URGENT MEDICAL DEVICE CORRECTION NOTIFICATION

Eliminate Potential Erroneous Electrical Reset Message

Software Update Available: CareLink SmartSync™ Device Manager

19 June 2025 | 15:11 SGT

Appendix - Verify Software Update is Complete

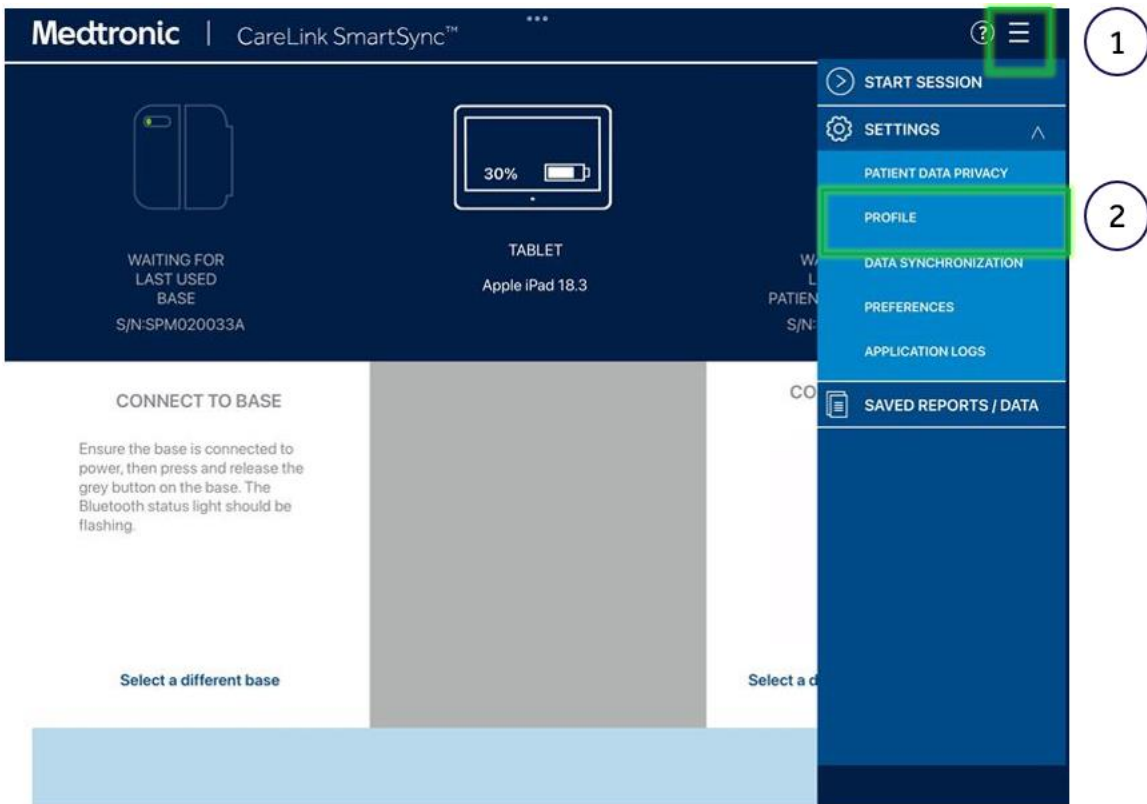
Confirm the updated application software version by:

- 1) Selecting the MENU in the upper right corner of the SmartSync App [1]
- 2) Selecting PROFILE [2]
- 3) Selecting the SOFTWARE tab and scrolling through the SOFTWARE INFO list [3]

If the software update for this issue has already been installed, you will see the following versions listed:

The Common/Platform application version is 4.2.3 (or higher) and the software version for each application listed in the Applicable Applications Appendix is at the updated version (or higher).
